Document Review Comments													
Drawings & Specifications													
Project Name:		FAA Comments - ARFF Station Consolidation											
Date:		12/14/2020

## DFW ARFF Discussion with DFW – December 14, 2020, 1pm - 2:15pm

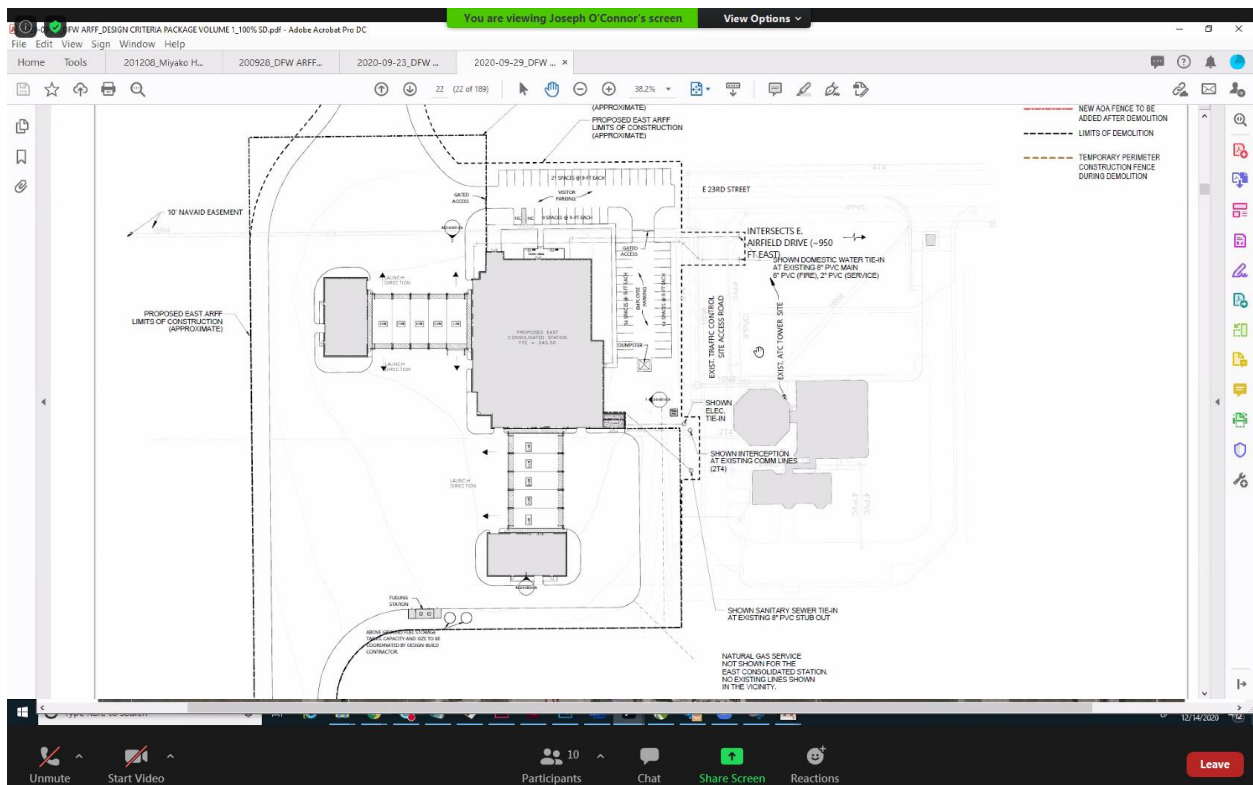
2. How will the ATCT utilities (i.e.-water, electric, phone) be affected? The consultant pulled up utility interface drawing (see below). It is limited to areas of proposed building. Domestic water tie is NNW of tower intersecting E Airfield drive. Electric tie in and communication line is west of the tower. Sanitary line is southwest of tower.
